# Tampa Electric Company (TECO)
# Coal Yard Assessment
## Stantec Job No. 198800347

September 2010
Revision 2

Stantec has been retained by Tampa Electric Company to provide a review of the coal field equipment at the Big Bend facility. The review scope boundaries are from the dock through conveyors L1 and L2 that bring the coal to the tripper deck in the power house.

Continental Conveyor and Equipment Co. Drawing E2-2A

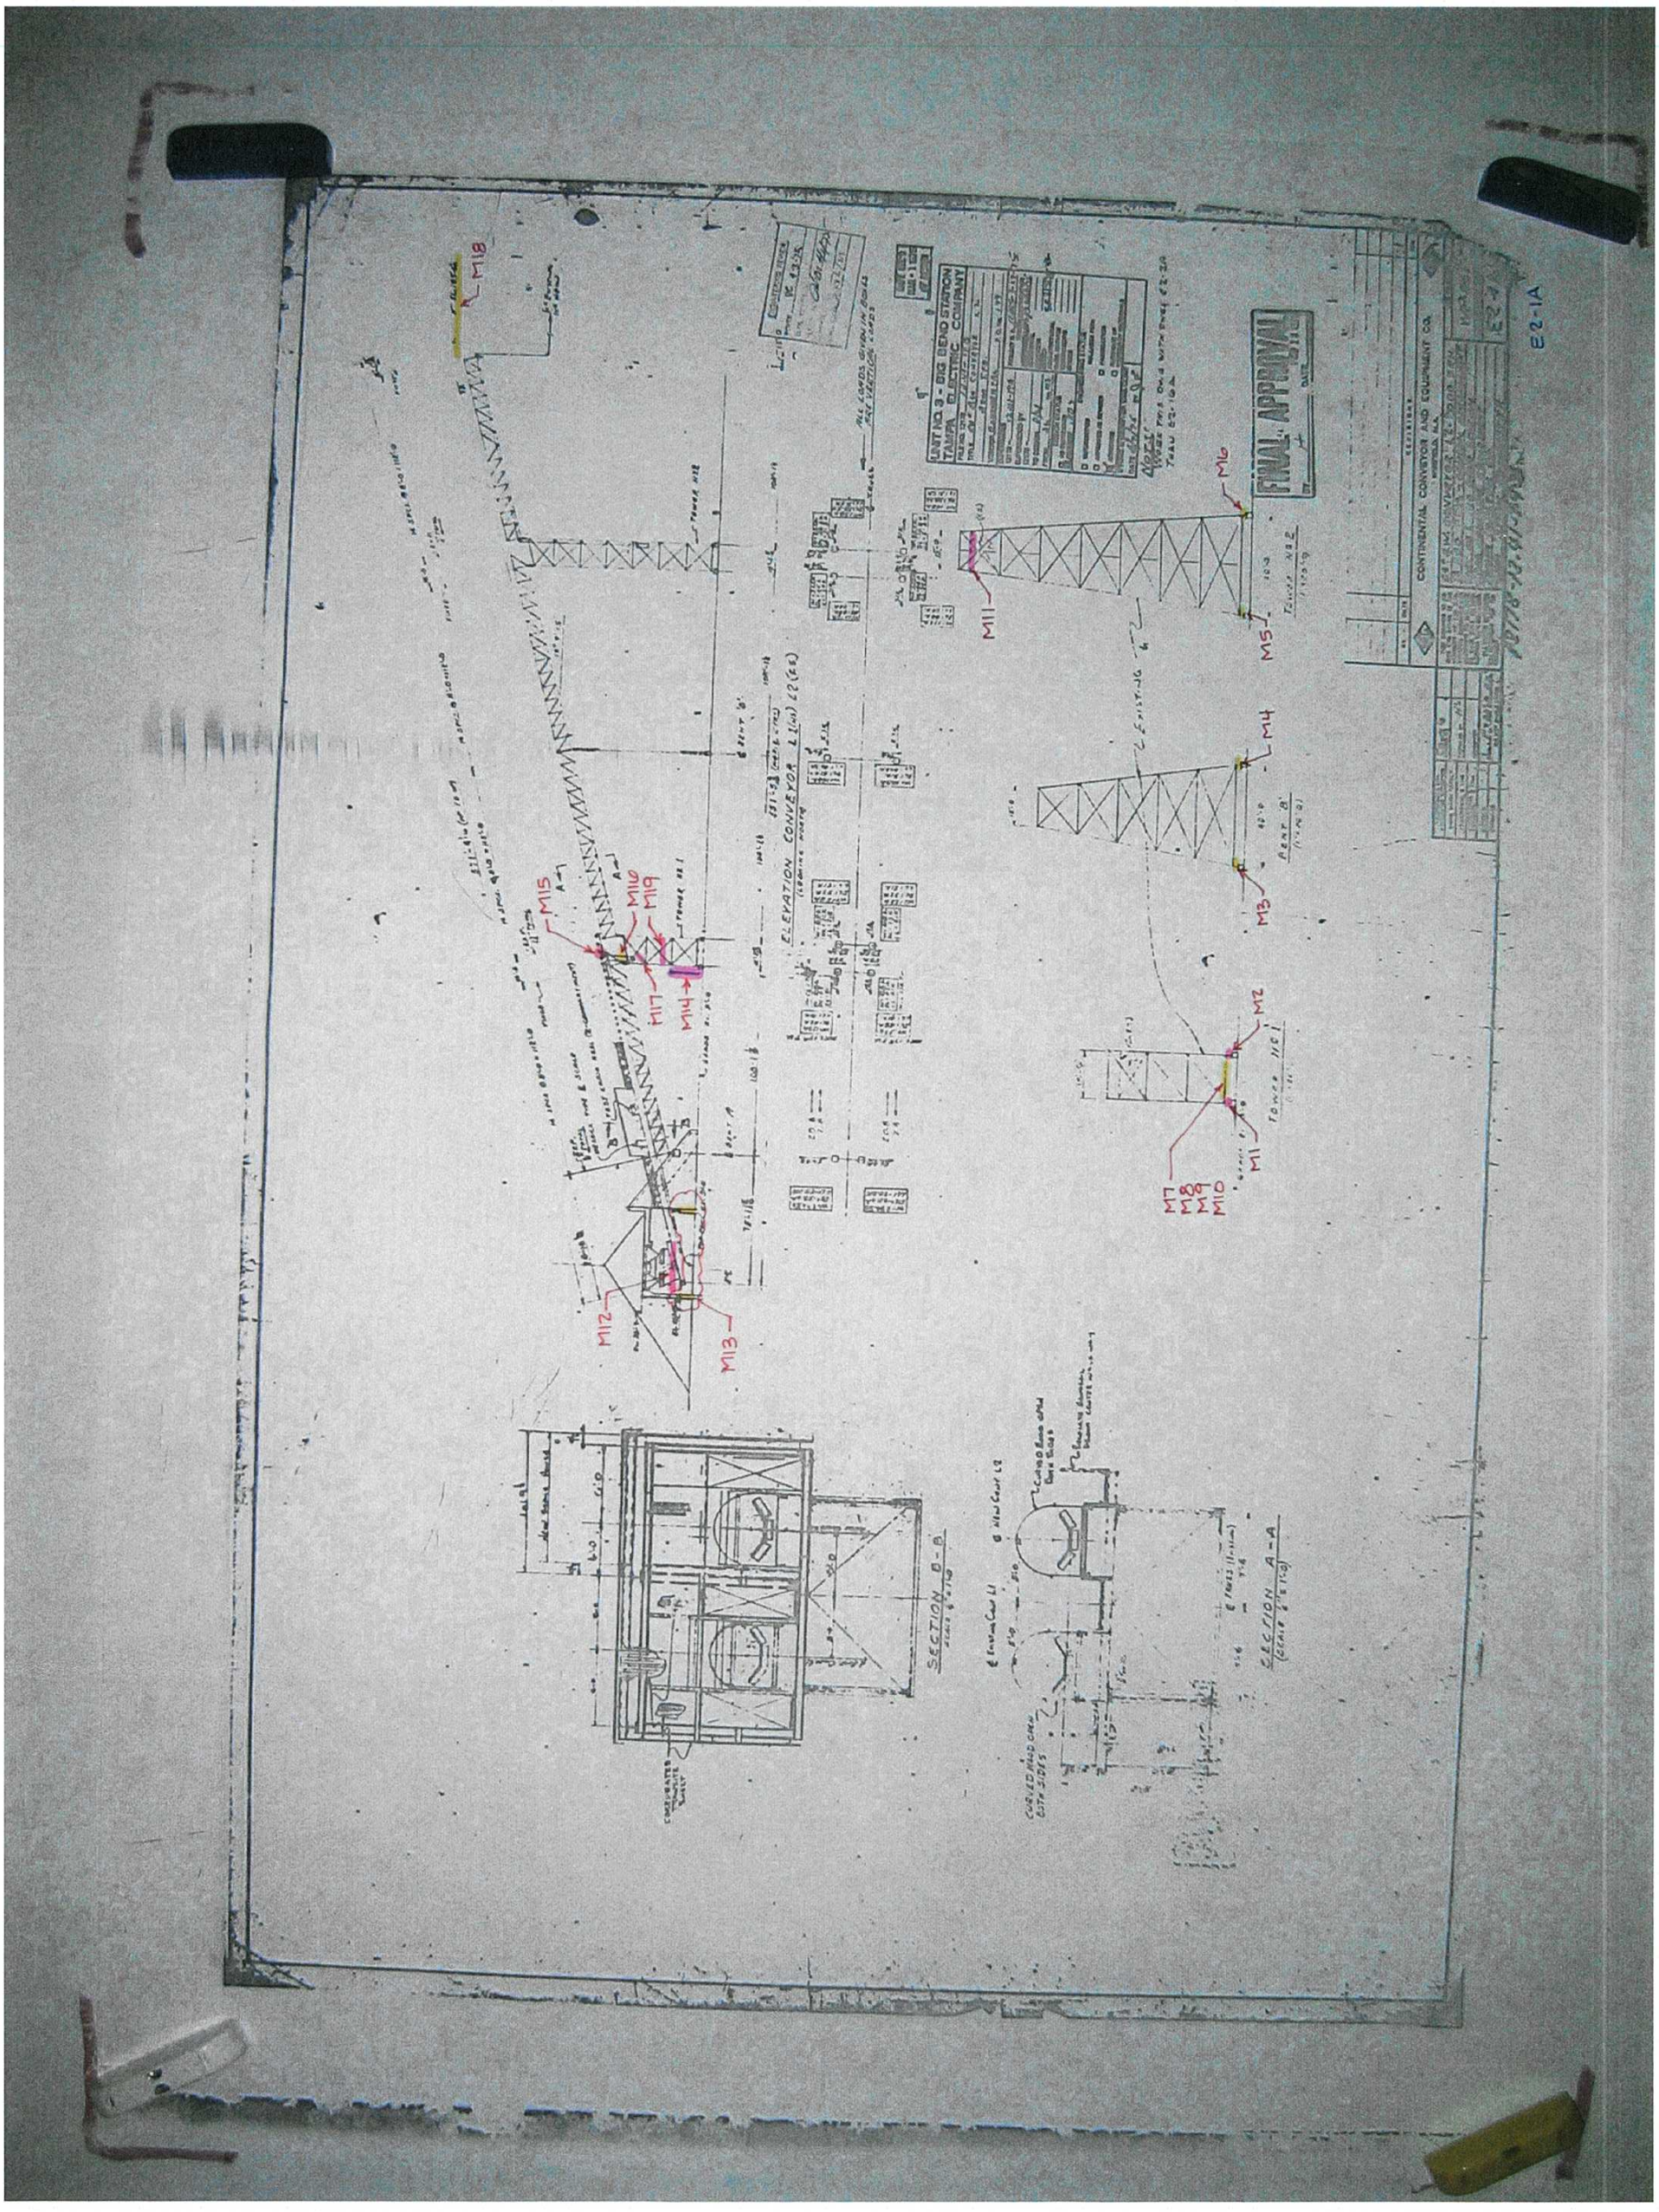
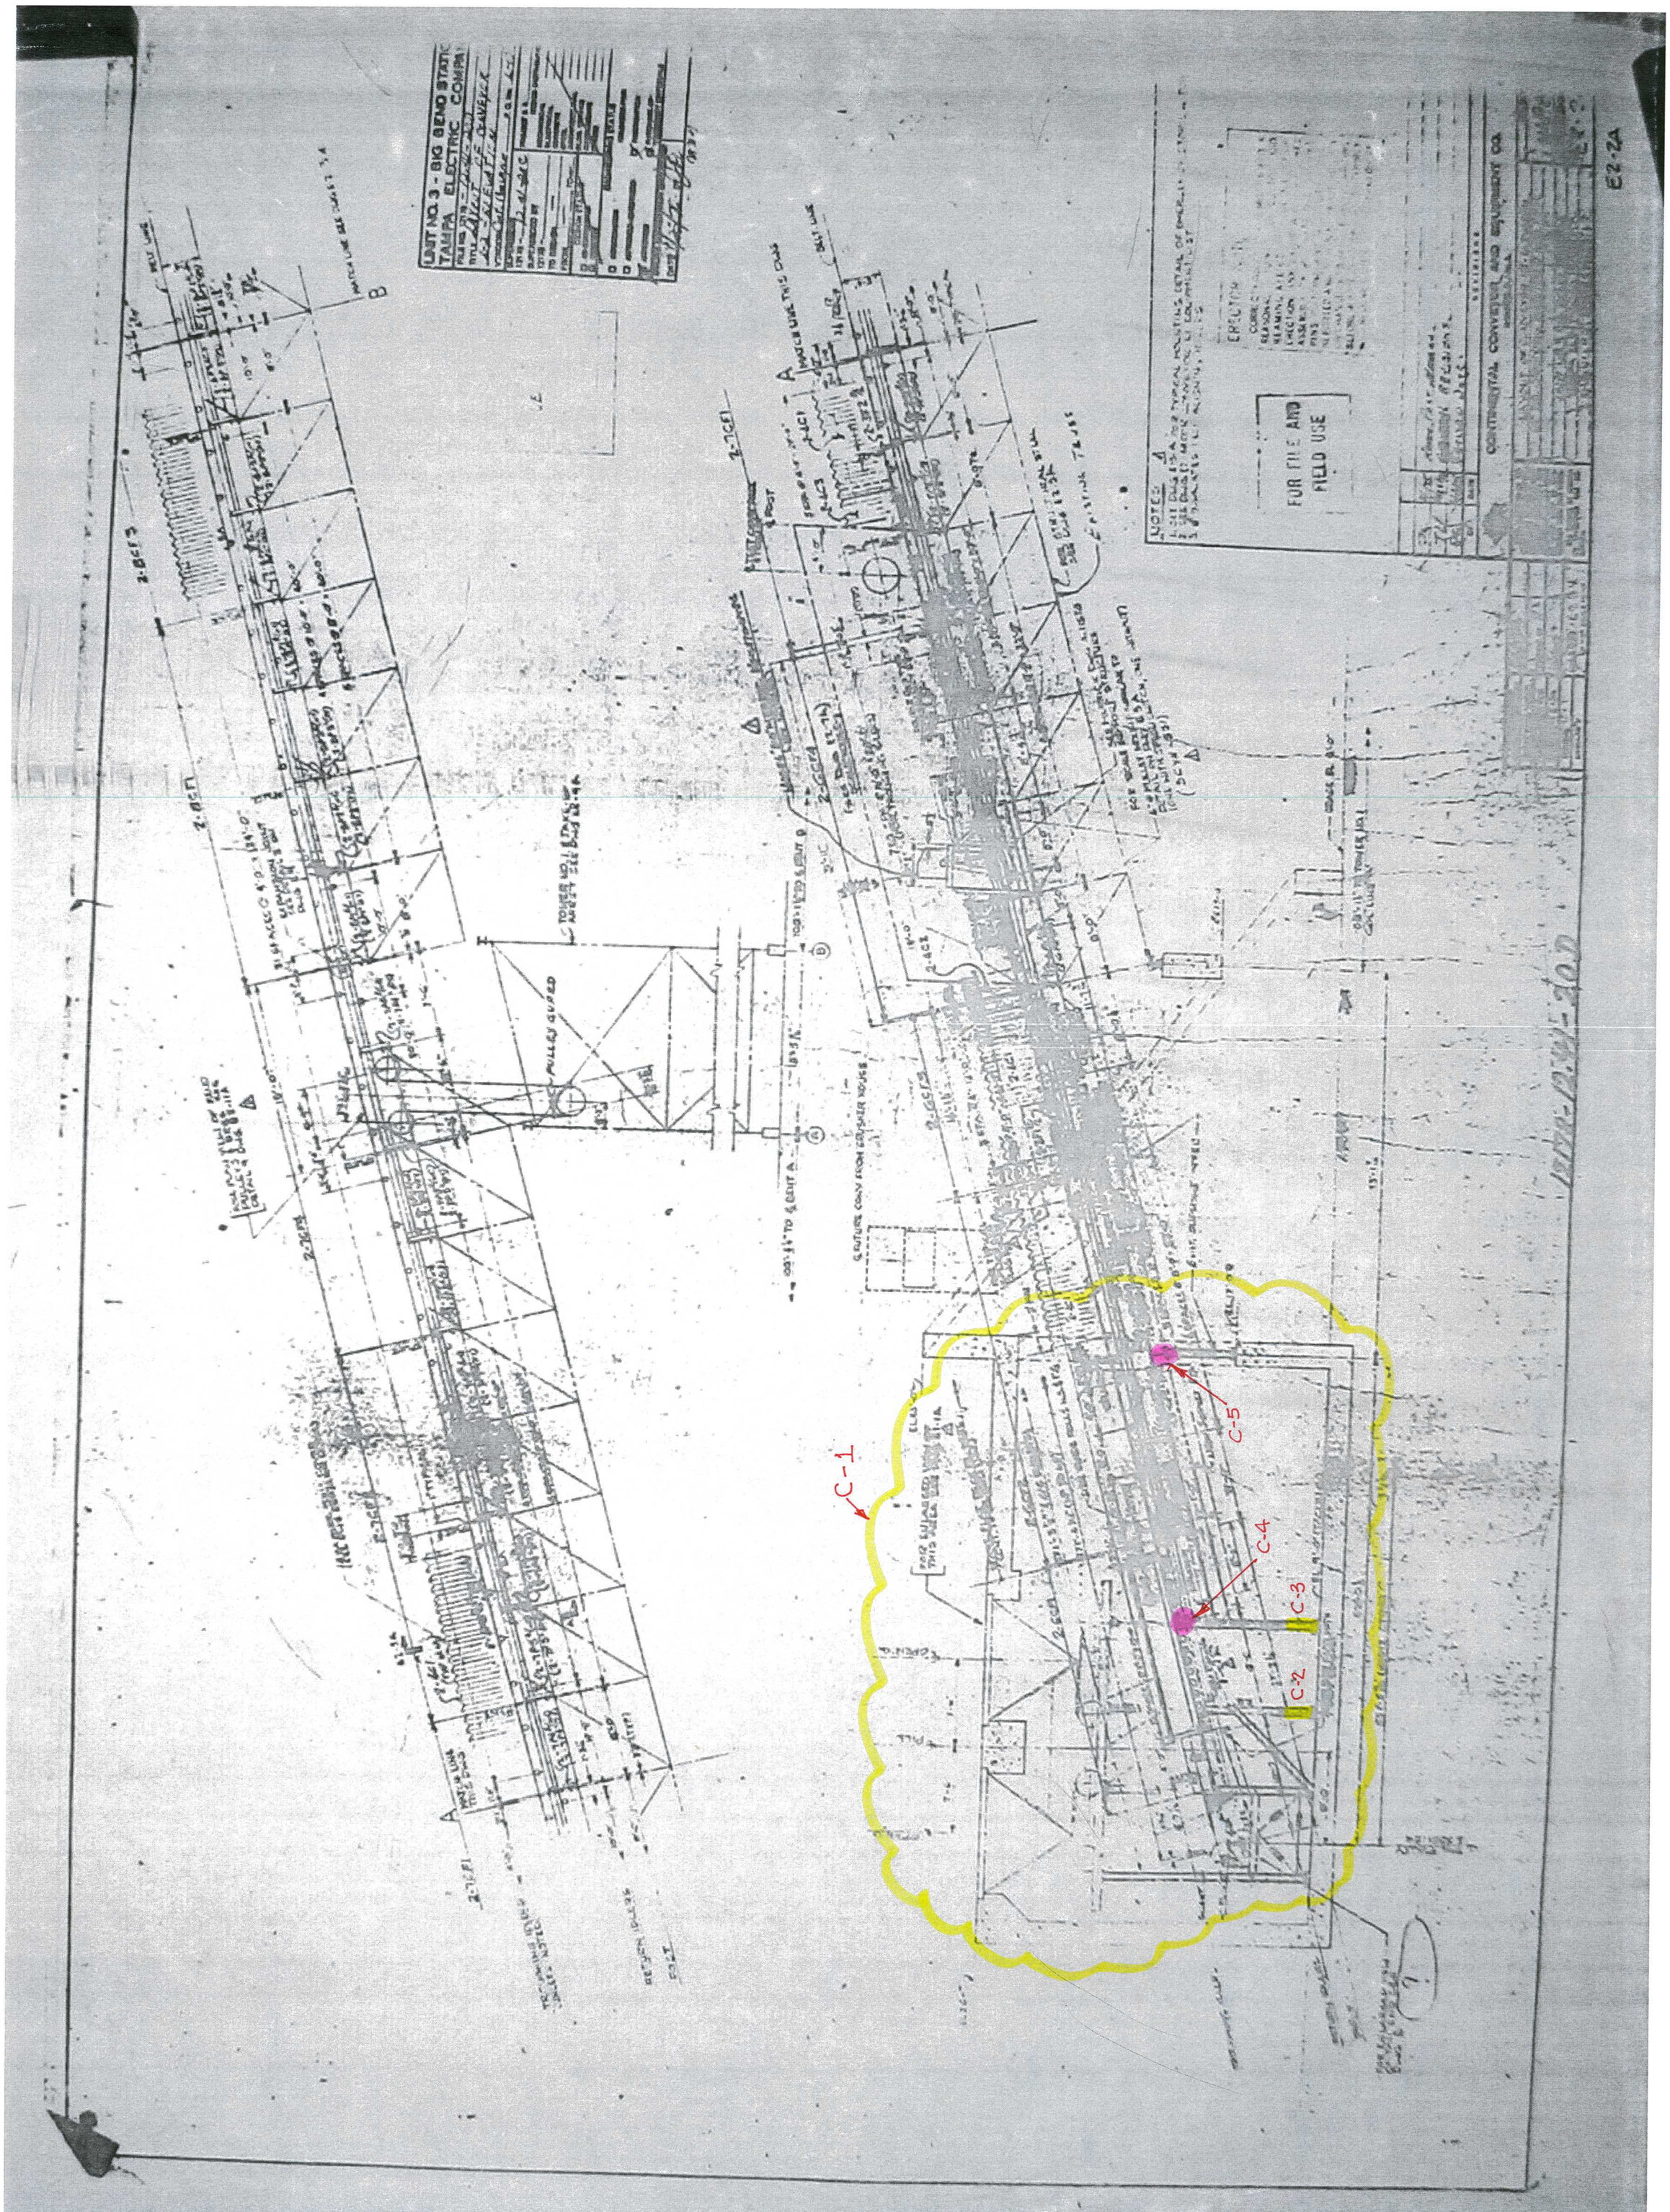
| C-4 & 5 | Steel beams running north and south that support conveyor L1 & L2 have severe corrosion and metal loss. Recommend replacement in kind. |

Comments for conveyor L1 pertain to conveyor L2 also.
